Access Compliance Report Public Rights-of-Way (Curb Ramps)

Main Street: E_RYALS_LN Cross Street: N_RENEE_ST Location: NW

ADA ID: RPAT210928104221 Ramp Type: Type 1 - Perpendicular Diagonal Initial Pass/Fail: Fail Overall Compliance: No Severity Score: 2

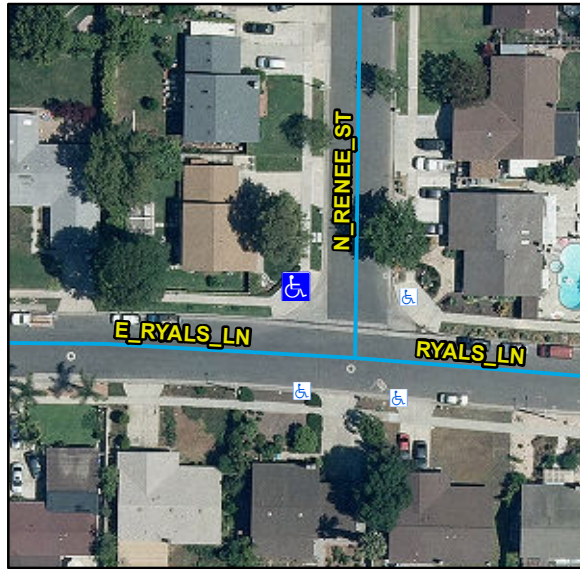
Compliance	Description	Data	Compliance	Description	Data
N/A	Ramp Length (in)	102	N/A	Flare Type LT	
Yes	Ramp Width (in)	48			N/A
Yes	Ramp Run Slope (%)	8.1	N/A	Flare Slope LT (%)	N/A
No	Ramp Cross Slope (%)	2.2	N/A	Flare Traversable LT	N/A
N/A	Landing Present	N/A	N/A	Flare Type RT	
N/A	Landing Length (in)	N/A			N/A
N/A	Landing Width (in)	N/A	N/A	Flare Slope RT (%)	N/A
N/A	Landing Run Slope (%)	N/A	N/A	Flare Traversable RT	N/A
N/A	Landing Cross Slope (%)	N/A	N/A	DWS Provided	N/A
N/A	Landing Movement Obstructed?	N/A	N/A	DWS Contrast	N/A
	Landing Movement Type	N/A	N/A	DWS Length (in)	N/A
N/A	Landing Shared	N/A	N/A	DWS Full Width	N/A
N/A	Clear Space	Yes	N/A	DWS Offset Left (in)	N/A
N/A	Clear Space To Crosswalk (in)	N/A	N/A	DWS Offset Right (in)	N/A
N/A	Marked Crosswalk 1	No	N/A	Marked Crosswalk 2	No
	Crossing 1 Direction	S		Crossing 2 Direction	E
	Marked Crosswalk 1 Width (in)	N/A		Marked Crosswalk 2 Width (in)	N/A

N/A	Ramp Inside Crosswalk 1	N/A	Yes	Ramp Inside Crosswalk 2	N/A
	Crossing 1 Slope (%)	4.2		Crossing 2 Slope (%)	4.1
	Crossing 1 Cross Slope (%)	0		Crossing 2 Cross Slope (%)	1.8
N/A	Gutter Ponding	N/A	No	Curb Slope	8.6
Yes	Gutter Lip Height (in)	0		Road Run Slope (%)	1.9
N/A	Gutter Run Slope (%)	N/A		Road Cross Slope (%)	0.6
N/A	Gutter Cross Slope (%)	N/A			
Yes	Overall Surface Condition: Acceptable		Yes	Perp Joint Present	Yes
	Cross Gutter Present?	Yes		Spandrel Present?	Yes
	Replace Cross Gutter?	No		Replace Spandrel?	No

Remove & Replace Curb Ramp With Two New Directional Ramps or Equivalent.
